Access Compliance Report Public Rights-of-Way (Curb Ramps)

Main Street: CHAPARRAL_CT **Cross Street:** CRESTVIEW **Location:** NE

ADA ID: RPRK211018175449 **Ramp Type:** Type 1 - Perpendicular Diagonal Initial Pass/Fail: Fail **Overall Compliance:** No **Severity Score:** 2

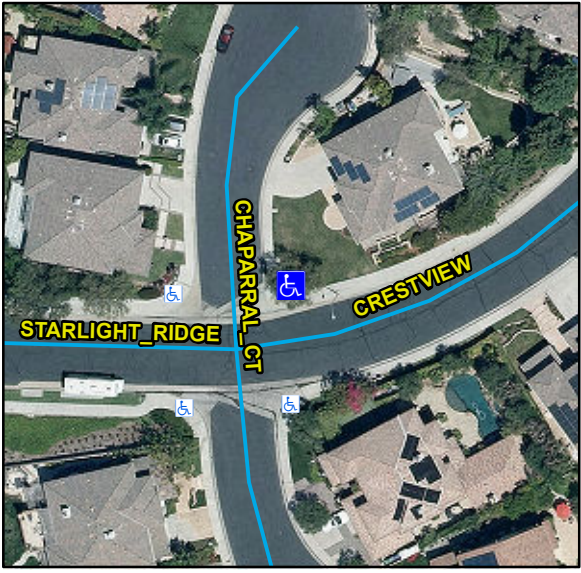
OC Std/PROW:
 R304.2.2, R304.5.3, R302.7.2, STD 1115

Possible Solutions:
Remove & Replace Curb Ramp With Two New Directional Ramps or Equivalent.
